Response to Brice Loose (reviewer 2)

Overview: The manuscript "The Roland von Glasow Air-Sea-Ice Chamber (RvG-ASIC): an experimental facility for studying ocean/sea-ice/atmosphere interactions" by M. Thomas and coauthors describes the experimental sea ice chamber at the University of East Anglia. The manuscript provides a thorough overview of the design and capabilities of the Chamber and it's attendant infrastructure. A series of experimental test runs have been carried out to benchmark the chamber behavior against mass balance, 1D models and to interrogate the internal consistency of instruments, including the techniques for measuring ice thickness. The manuscript is well-written and clearly laid out and, in my opinion, does an excellent job of featuring the Chamber and providing future users with valuable metrics they can use to design their experiments and test their results. It is clear that the facility is well-equipped for gas measurements as well as radiation studies – both very exciting and relevant phenomena to polar and sea ice research. The benchmark tests and presentation of data are all clear and easy to understand. My only comments have to do with the content and de

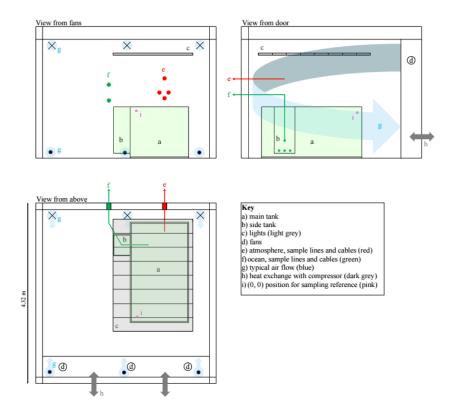
Specific comments: Suggest combining Figures 1 and 3 to make a single unifying diagram of the Schematic in a 3 x 2 panel configuration. Photos could be paired with the diagram that comes closest to revealing that perspective. Common features in the schematic could be annotated in the photos. For the schematics, I would encourage more use of shading to distinguish the tank from the cold room (as was done in 'view from above') and different line thicknesses to help reveal tank and chamber outlines. Clearly indicate what is the chamber – this refers to the cold room and all its contents? It might be helpful to include some fan icons and tighten up the arrows and other graphic elements.

Line 199: Do "cold room" and "chamber" refer to the same physical enclosure? I had some difficulty understanding what was referred to by "chamber" as opposed to "tank" and "cold room". It might be helpful to explicitly define what is encompassed by the word "chamber" in the text and in the combo of Figures 1 and 3.

We have amended the schematic following these useful comments. See below:

After some thought and a few attempts, we chose not to merge figures 1 and 3. Our main reason was that the photos in figure 1 do not correspond to the panels in figure 3, and we felt combining the figures might therefore cause some confusion. A secondary consideration was that, in a combined figure, it is difficult to show the three photos and the schematic as large as we would like. We have added labels to figure 1 (see below) that correspond to figure 3.

This is a good point. We have added the following text, in a prominent position at the end of Section 2, to clarify what we mean by the 'chamber'.

We use 'chamber' to describe the experimental system. When the tank is exposed to the entire coldroom, as for all the experiments presented here, the coldroom is the chamber.
